FALCON SERVICE BULLETIN

FALCON 900EX FALCON 900EX EASy FALCON 900DX

No 285-R1

**LIGHTING
EXTERIOR LIGHTING
ELECTRICAL BONDING OF WHELEN FIN TIP ANTI-
COLLISION LIGHT**

Figure 1: ELECTRICAL BONDING STRIPS INSTALLATION

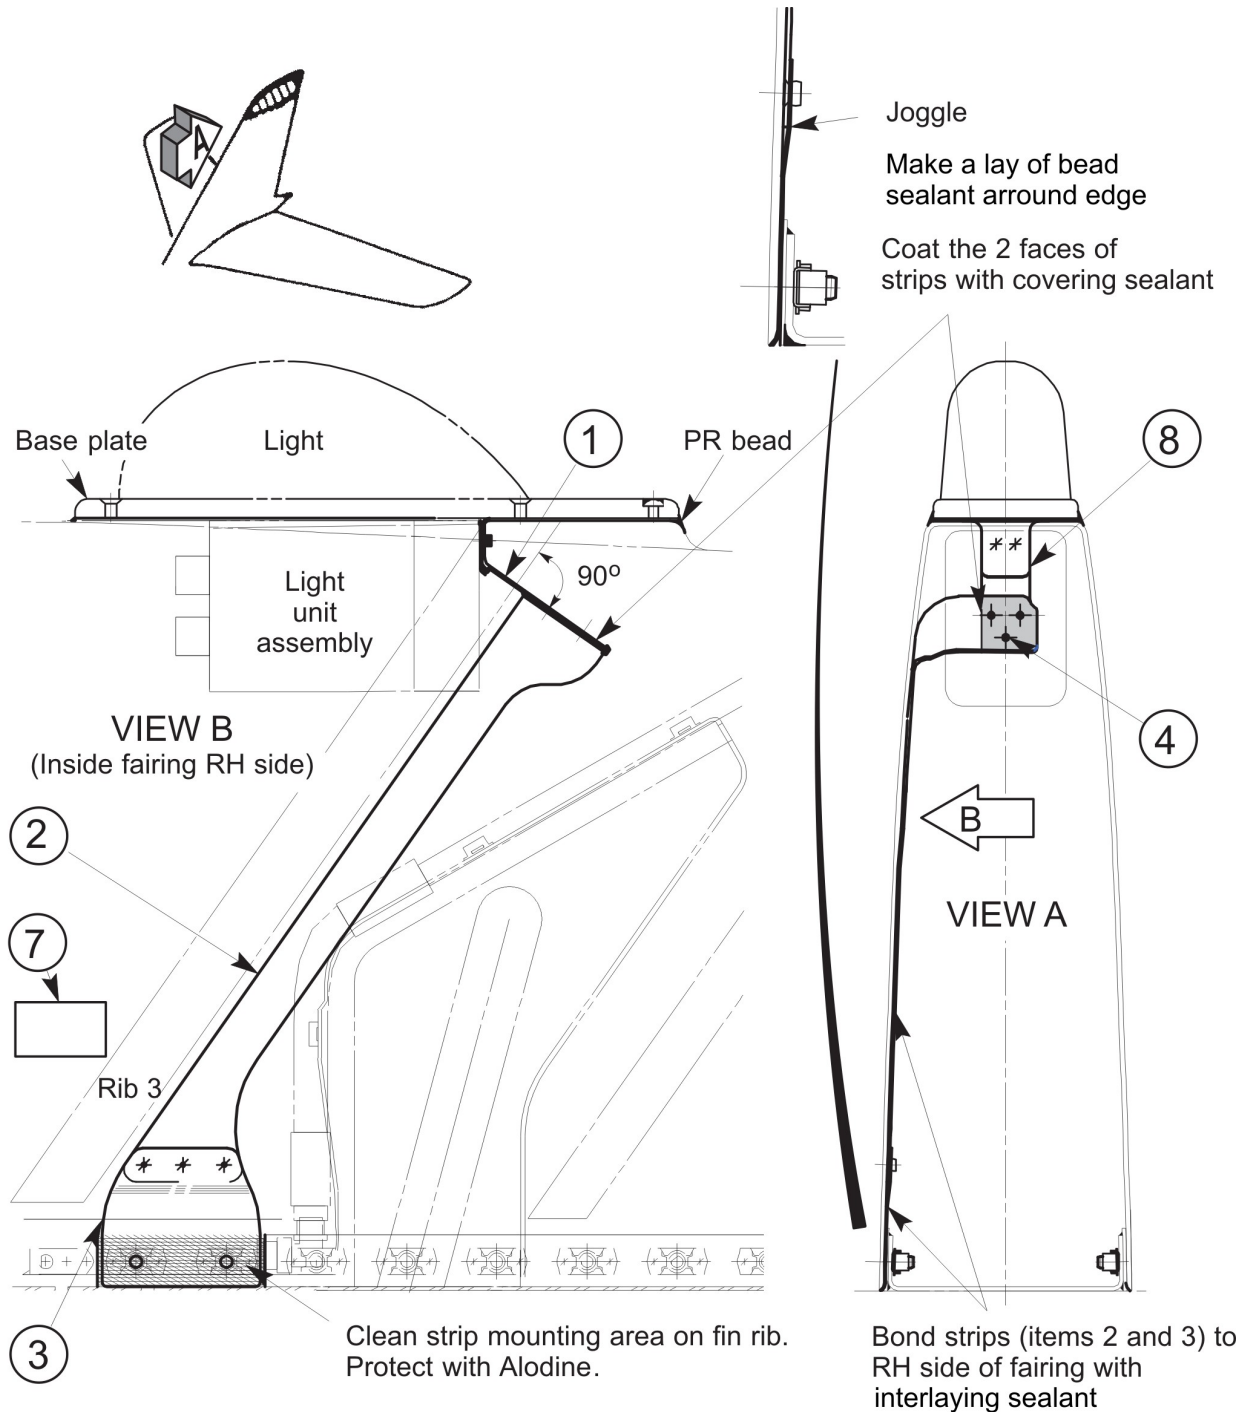
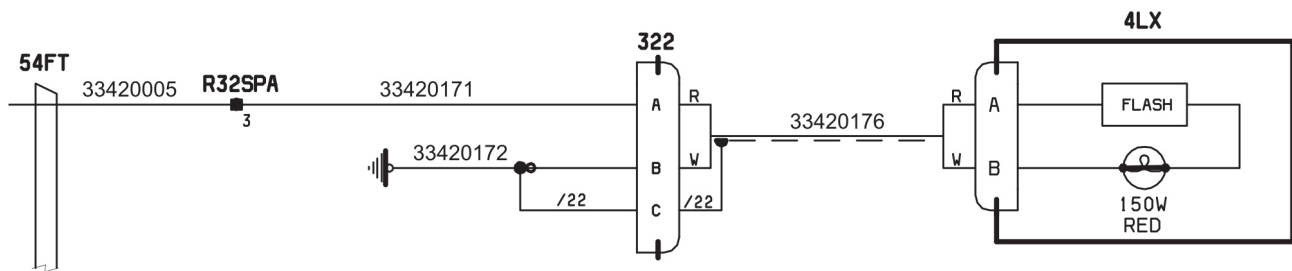
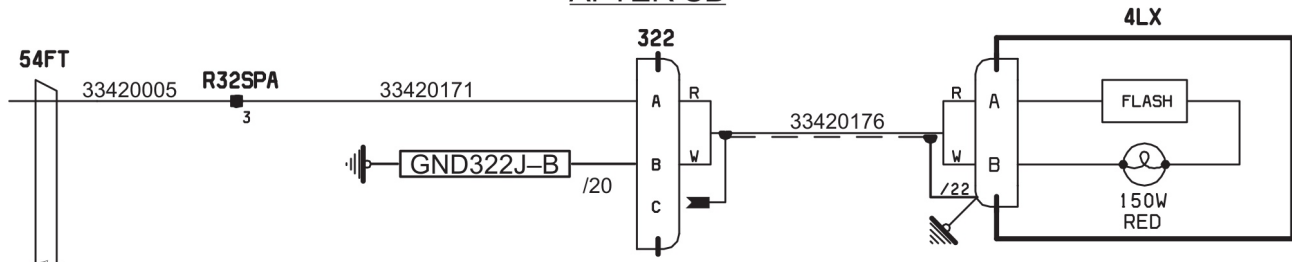
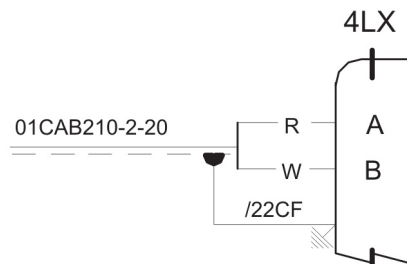
In accordance with **fig. 1**:

- (1) Cut out the run outs of the compound seal to obtain a plane mounting surface.
- (2) Set the mounting-base bonding strip (item 1), equipped with plate (item 8), into place on the fairing. Attach with two screws.

- (3) Fold the tab of the strip to a 90° angle with respect to the fairing's rib.
- (4) Pin the strip assembly (items 2 and 3) to the fairing.
- (5) Position the strip assembly (items 2 and 3) in contact against the RH side panel of the fairing and on strip (item 1). If necessary, rework the shape of the strips to obtain proper contact.

- (6) Remove the strip assembly (items 2 and 3).
- (7) Install double-sided adhesive tape on the face coming in contact with bonding strip (item 1).
- (8) Re-install strip assembly (items 2 and 3). Pin to hold in contact against the fairing.

- (9) Install strip (item 1) over the strip assembly, pressing firmly at the contact area.
- (10) Remove the strip assembly (items 1, 2 and 3).
- (11) Counterdrill bonding strip (item 2) to a diameter of 0.1 in (2.5 mm). Disconnect the strips and discard the adhesive tape, remove all remaining adhesive.

- (12) Enlarge the holes drilled in the strips to a diameter of 0.126 in (3.2 mm). Assemble bonding strips (items 1 and 2) using rivets (item 4). Coat the faces of the strips with **covering sealant** making a bead at the contour edge with **bead sealant**.

- (13) Clean the contact surfaces of the light unit assembly, of the strips, and of the fairing using **MEK**.
- (14) Coat the strip assembly (items 2 and 3) with **interlaying sealant**.

- (15) Connect and safety connector (4LX) to the light unit.
- (16) Set the strip assembly and the light unit assembly into place in the fairing and attach the light assembly to the fairing. Smooth out the PR in excess around the strips.

- (17) Use a shim to wedge strip assembly (items 2 and 3) in contact against the fairing's wall. Allow to cure.
- (18) Temporarily position the fairing at the fin tip and mark the location of strip (item 3).
- (19) Strip the paint off the fin tip rib at the location marked for strip (item 3). Protect the stripped area with **alodine**.
- (20) Install the retainer, glass cover and seal the gasket, the lens, and the retainer plate (Refer to **IPC fig. 33-40-10-50**, items 190, 180 and 150).
- (21) Apply a **bead sealant** around the attaching plate.

**Figure 2: AIRCRAFT F900EX S/NS 1, 12 THROUGH 195 - AIRCRAFT F900DX 601 THROUGH 620
 (MODIFICATION F900EX M1682 FACTORY APPLIED)**

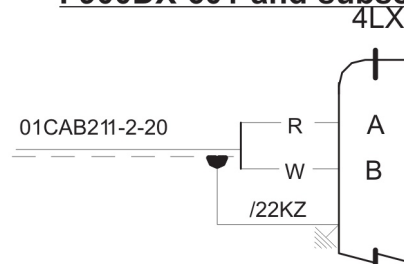
Modify the shield connection in accordance with instructions depicted hereafter and using:

- **fig. 2** on aircraft with serial numbers 1, 12 and subsequent (modification F900EX M1682 factory applied),
- **fig. 3** on aircraft with serial numbers 2 through 11 if SB F900EX-25 if applied.

Dimension A:

- Connector with front extraction: 1.38 in (35 mm).
- Connector with rear extraction: 1.97 in (50 mm).

Self-soldering sleeves must be staggered at the extremity of the wiring assemblies so as to prevent a bulge on the bundle.

Figure 4: RE-ROUTING THE WIRING - AIRCRAFT WITH WIRING ROUTED OVER RIB 2

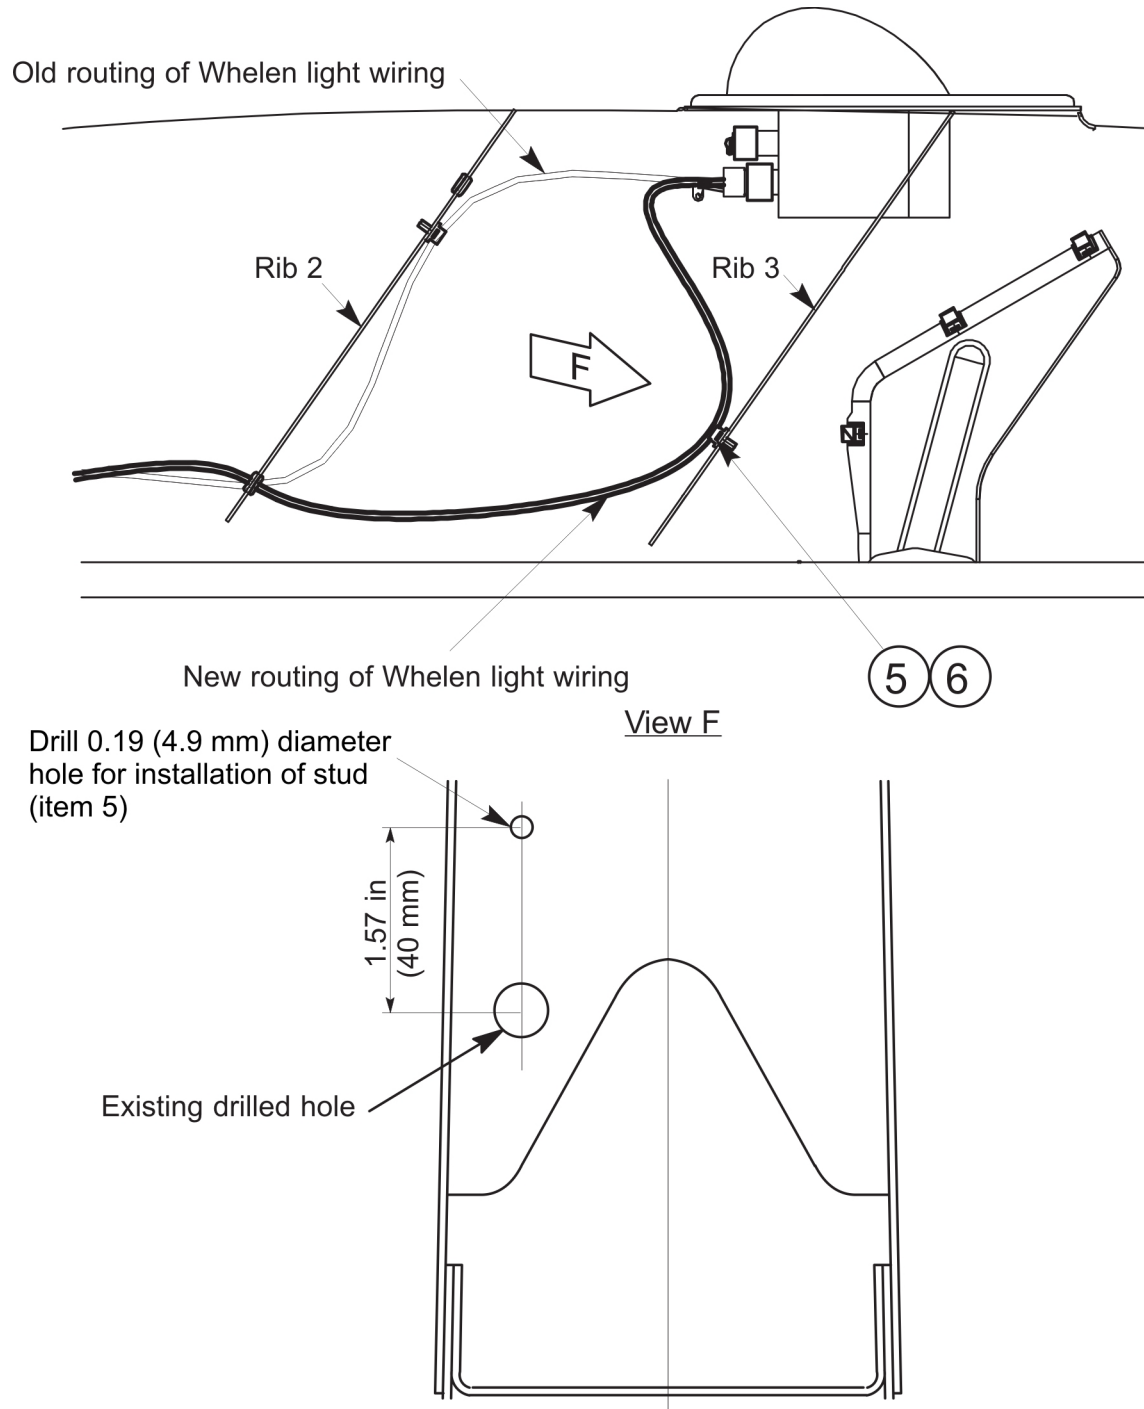
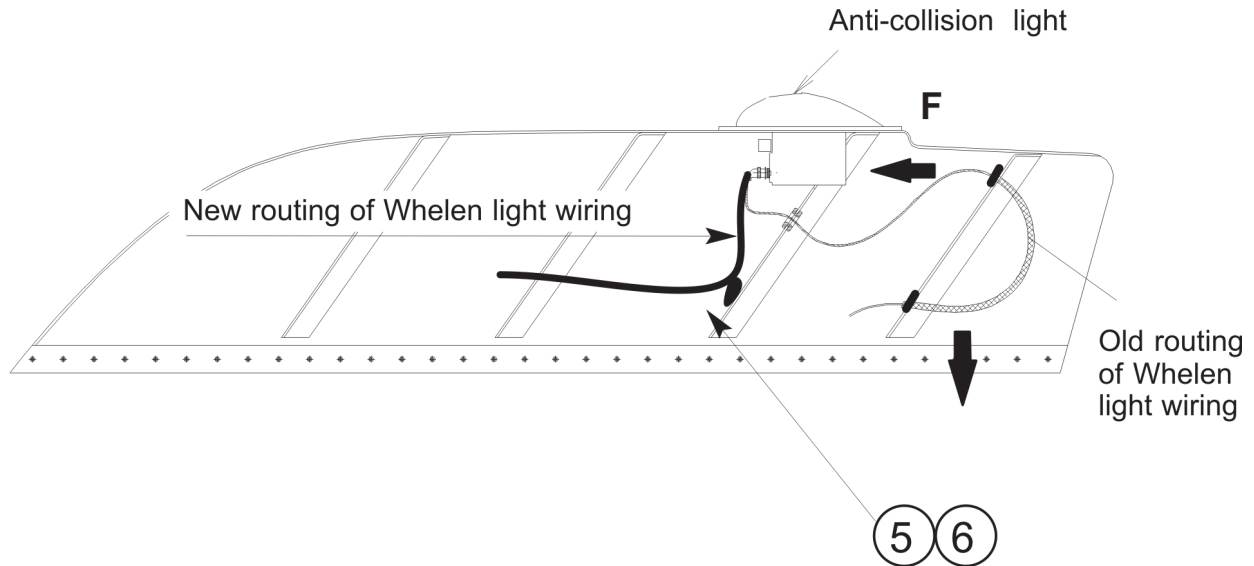
In accordance with **fig. 4**:

- (1) Remove the WHELEN light unit assembly.
- (2) Drill a 0.19 in (4.9 mm) diameter hole through the rib of the fairing.
- (3) Install new clamping stud (item 5) on rib 3.
- (4) Unclamp the wiring from rib 2.
- (5) Clamp the wiring to rib 3.
- (6) Connect connector (4LX) to the WHELEN light.
- (7) Attach the light unit assembly to the fairing.
- (8) Install the gasket, the glass cover, and the retainer (Refer to **IPC fig. 33-40-10-50** , items 180, 190, 260).
- (9) Apply **bead sealant** around the retainer.

Figure 5: RE-ROUTING THE WIRING - AIRCRAFT WITH WIRING ROUTED AROUND THE BACK OF FAIRING

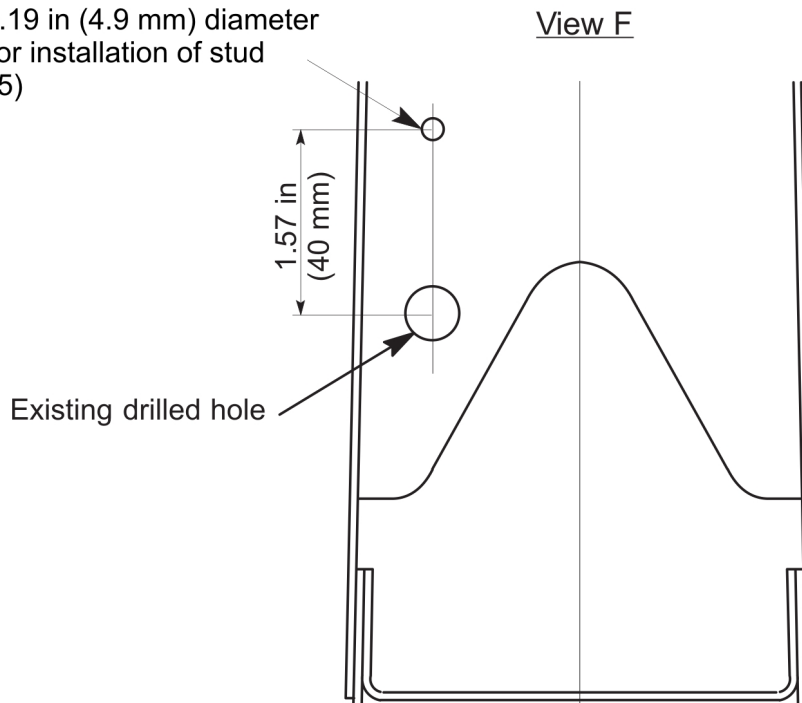
In accordance with **fig. 5**:

- (1) Remove the WHELEN light unit assembly.
- (2) Drill a 0.19 in (4.9 mm) diameter hole through the rib 3 of the fairing.
- (3) Install new clamping stud (item 5) on rib 3.
- (4) Remove contacts from connector (4LX).
- (5) Adjust the wiring length for proper re-routing in accordance with **fig. 5**.
- (6) Fit the cut wires with new contacts and insert them into connector (4LX).
- (7) Clamp the wiring to rib 3.
- (8) Connect connector (4LX) to the WHELEN light.
- (9) Attach the light unit assembly to the fairing.
- (10) Install the gasket, the glass cover, and the retainer (Refer to **IPC fig. 33-40-10-50** , items 180, 190, 260).
- (11) Apply **bead sealant** around the retainer.
